FINAL  
ENVIRONMENTAL STATEMENT

CALLEGUAS CREEK  
SIMI VALLEY TO MOORPARK  
VENTURA COUNTY, CALIFORNIA

Prepared by  
Office of the Chief of Engineers  
Department of the Army  
Washington, D.C. 20314

June 1976

**PLATE 4**  
**PRIME AGRICULTURAL LAND**

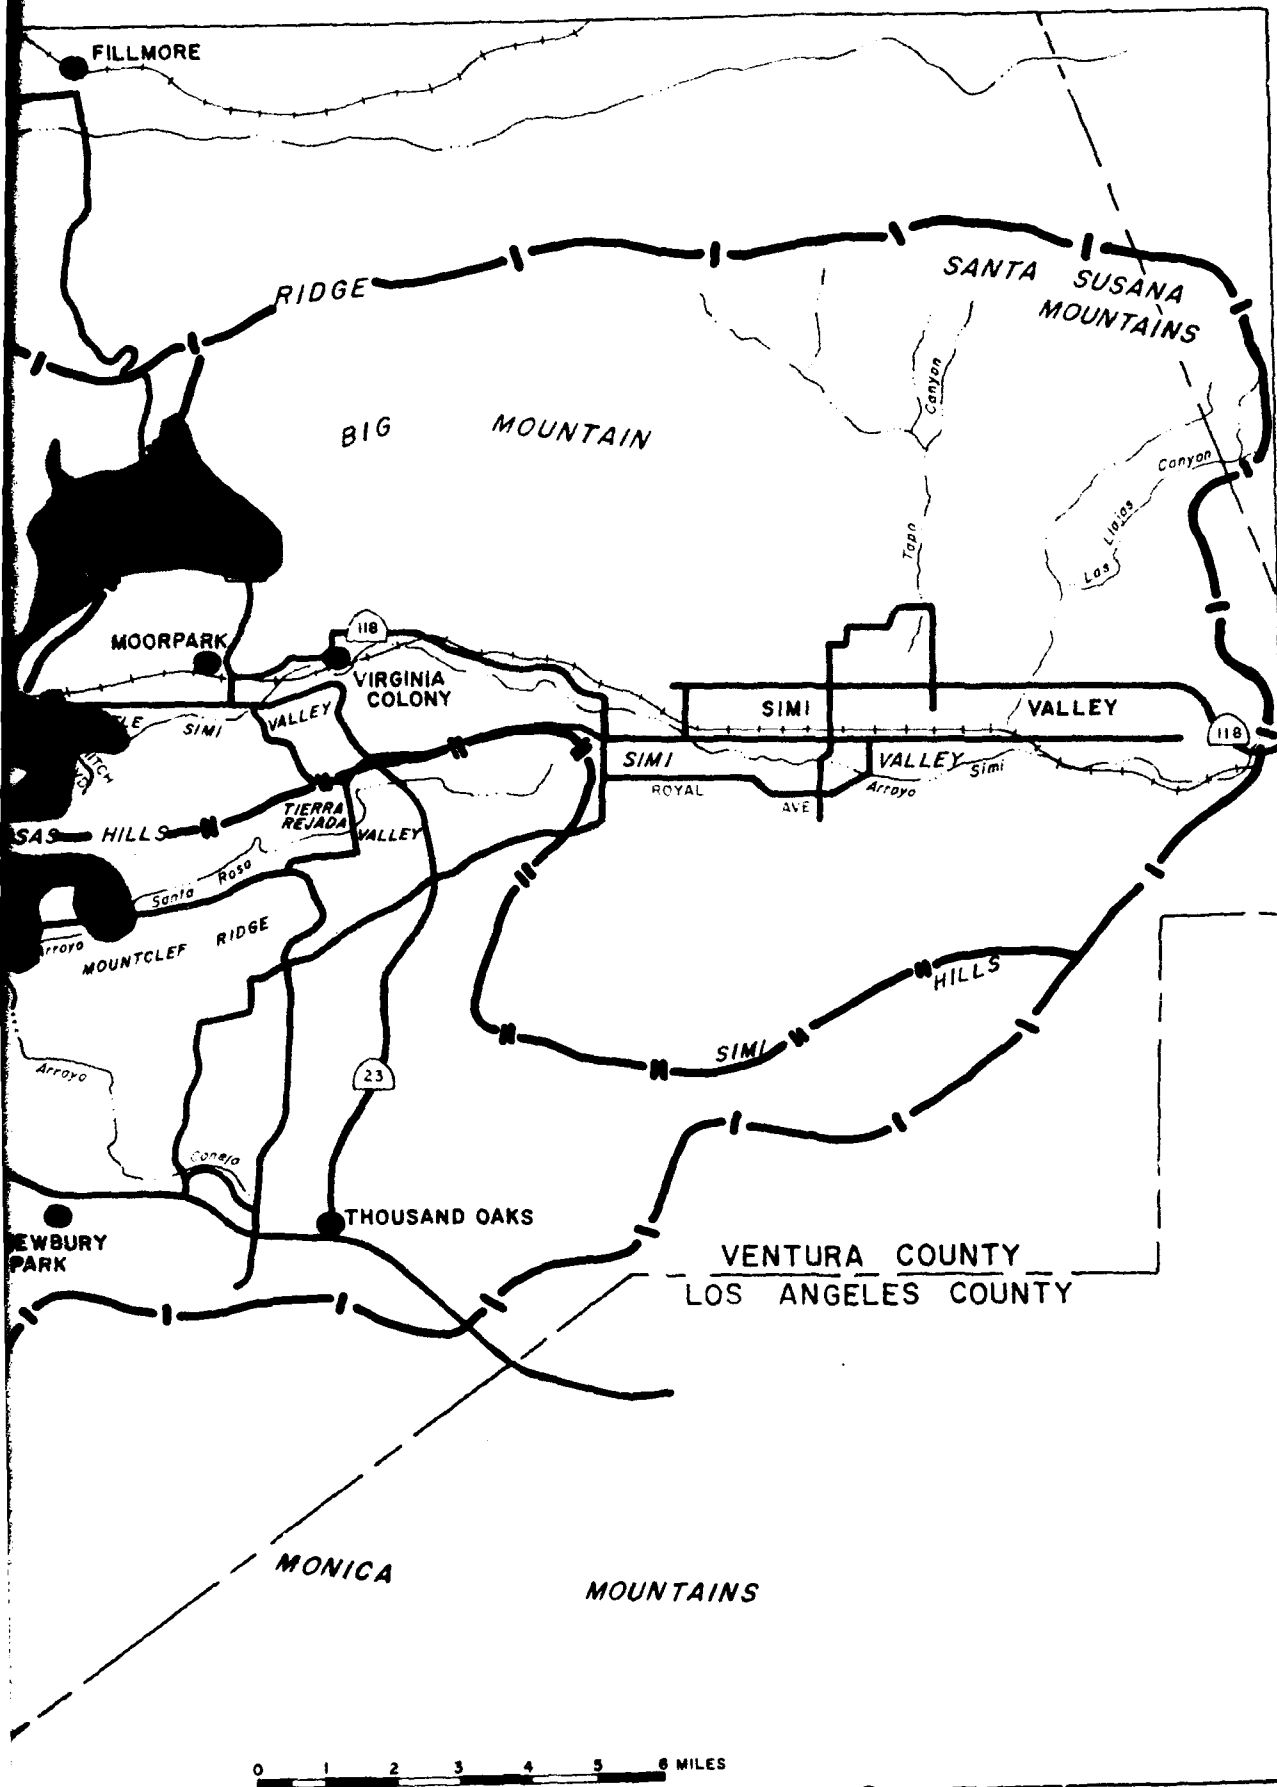
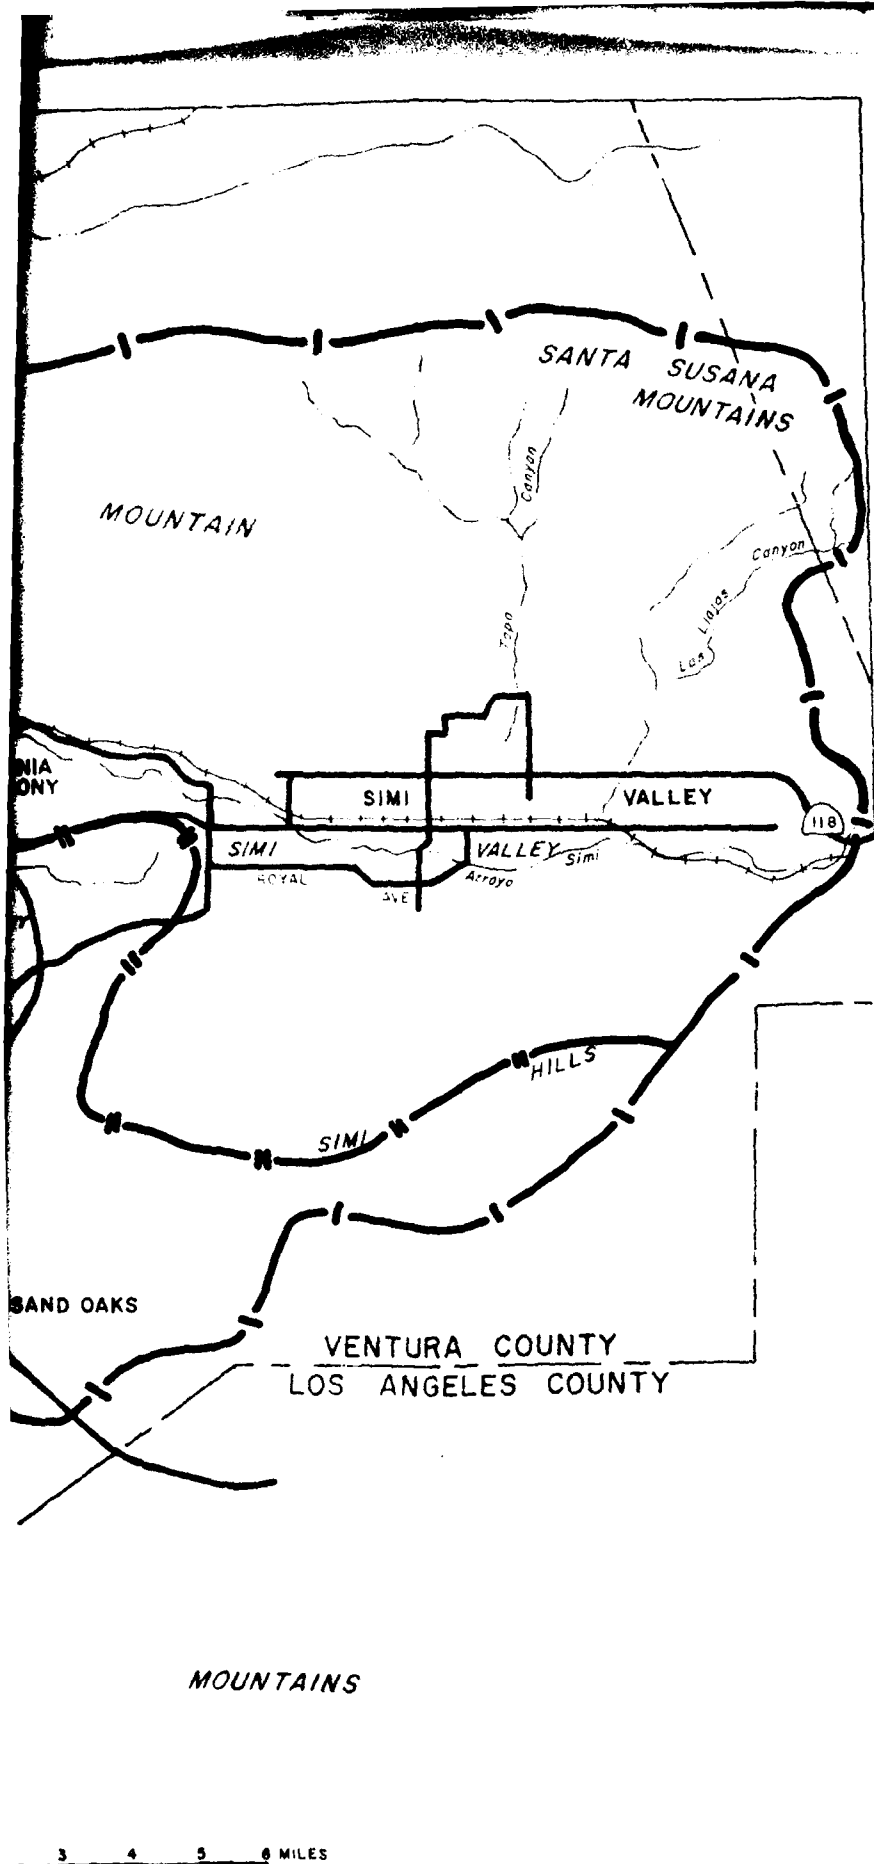
Comment: Plate 4 identifies prime agricultural land within Ventura County. For clarification purposes, the area shown on this plate is the Agricultural Element of the Ventura County General Plan as adopted by the Board of Supervisors.

11. Plate 4 identifies prime agricultural land within Ventura County. For clarification purposes, the area shown on this Plate is the Agricultural Element of the Ventura County General Plan as adopted by the Board of Supervisors.

**PLATE 5**  
**NATURAL COMMUNITY**  
**DISTRIBUTION**

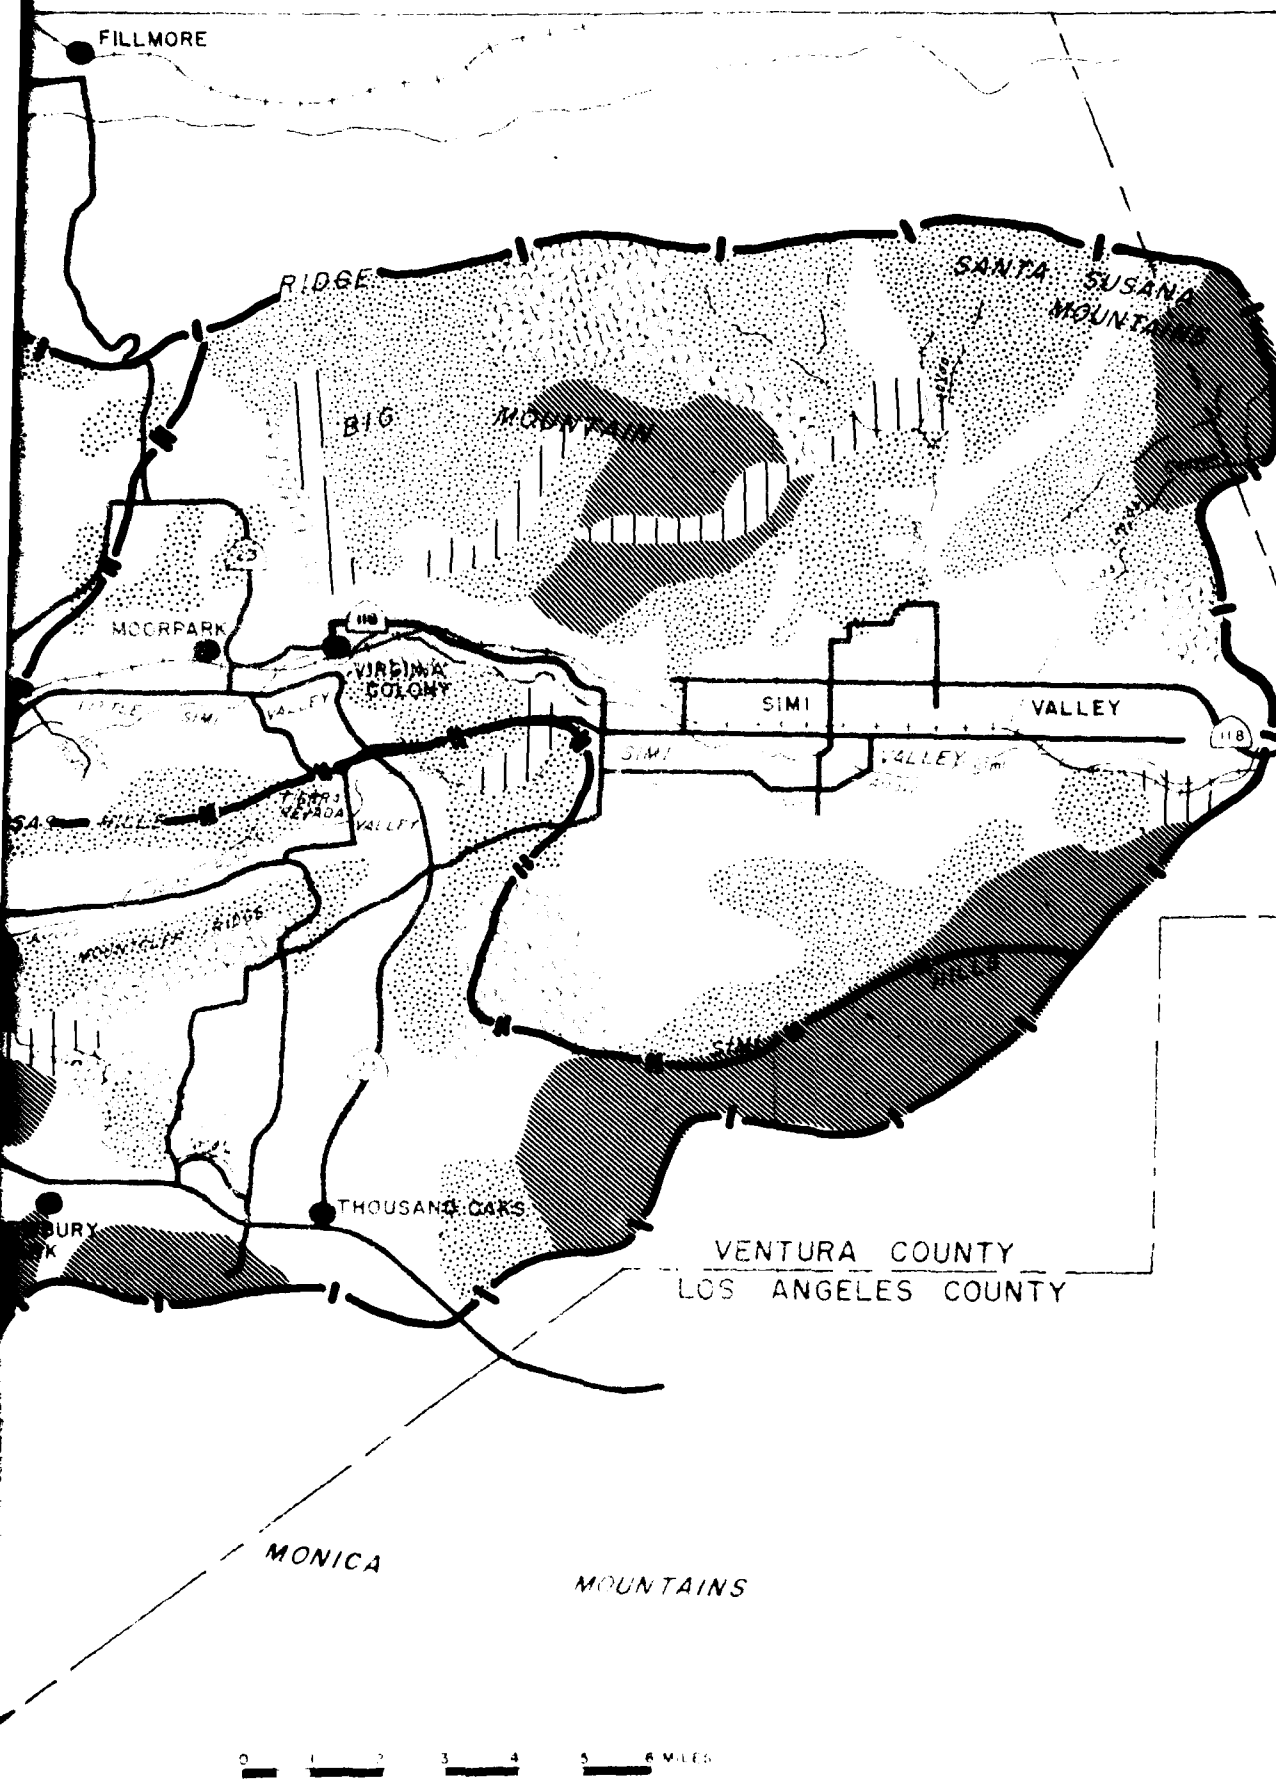
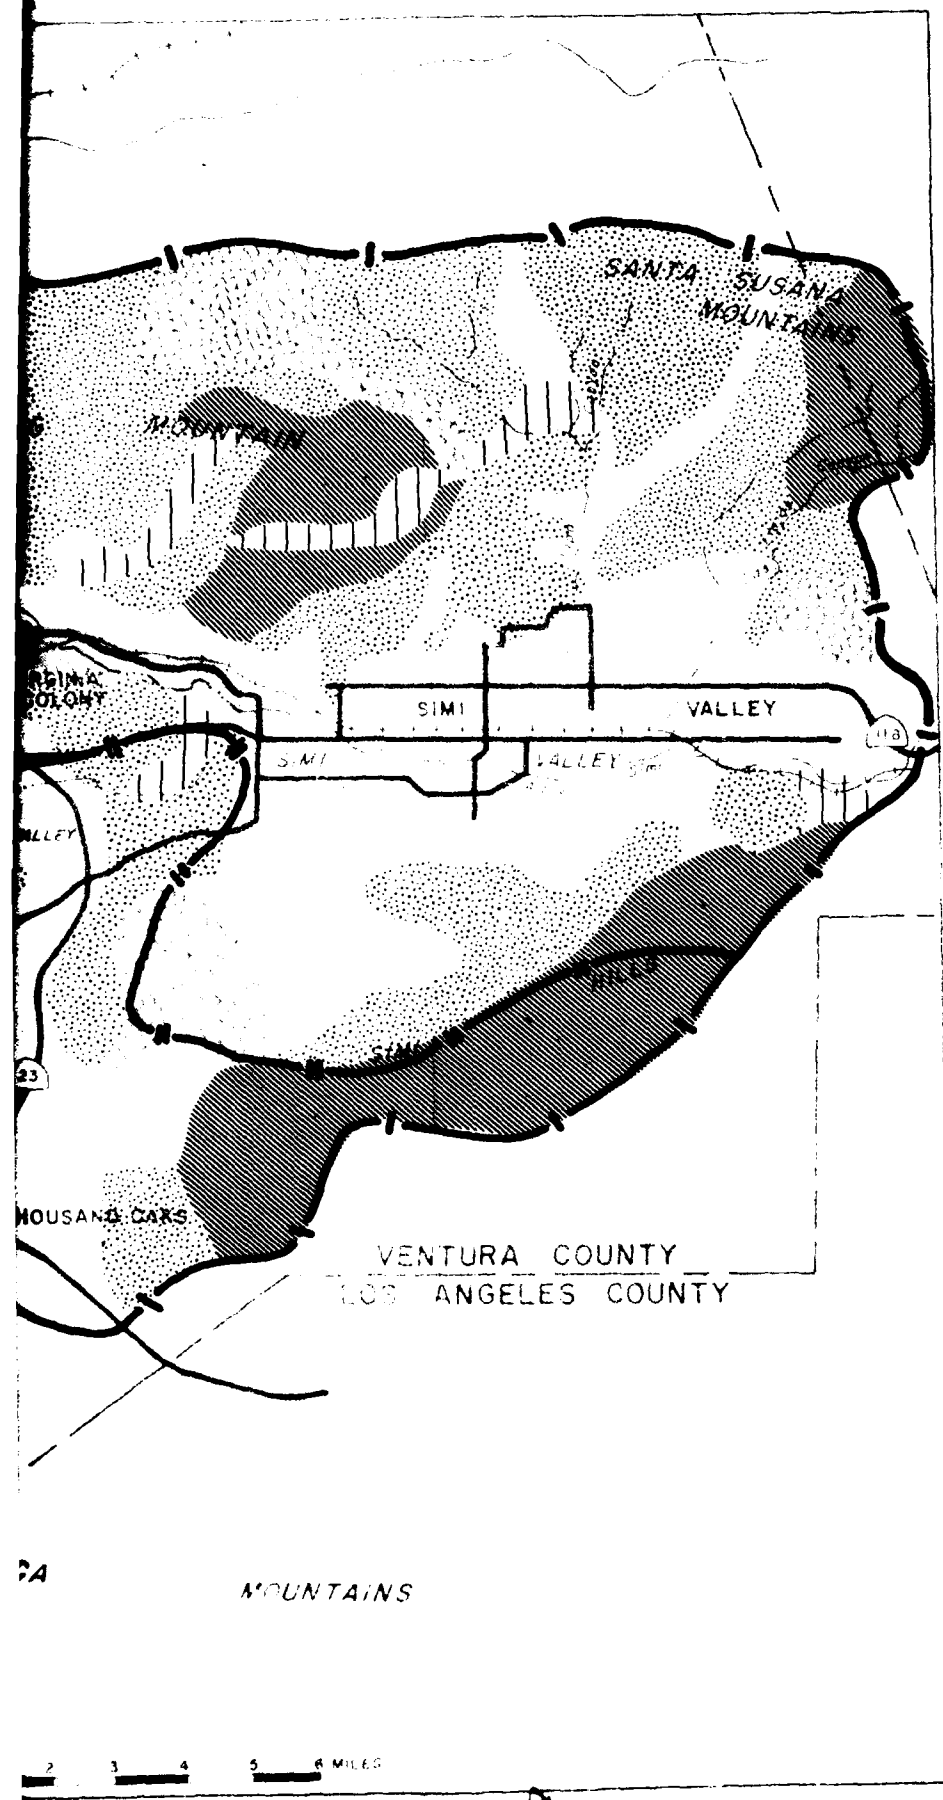
**Comment:** The statement should take cognizance of the project's impact on biological communities in the reach between Simi Valley and Moorpark. Perhaps more recent photographs should be included in the statement to indicate the lush vegetation that has developed in the area and this condition reflected in plates 5, 6, and 7.

**Response:** The only impact on the biological communities between Simi Valley and Moorpark would result from recreation trails and use of these trails. The environmental statement has been modified to reflect the impact of recreation on the biological communities. The photos were taken in the spring of 1973. Presence of bush riparian growth is dependent on the amount of waterflows in the streambed. Larger flows remove growth. Plates 5, 6, and 7 do reflect the riparian community in relation to the map topics.
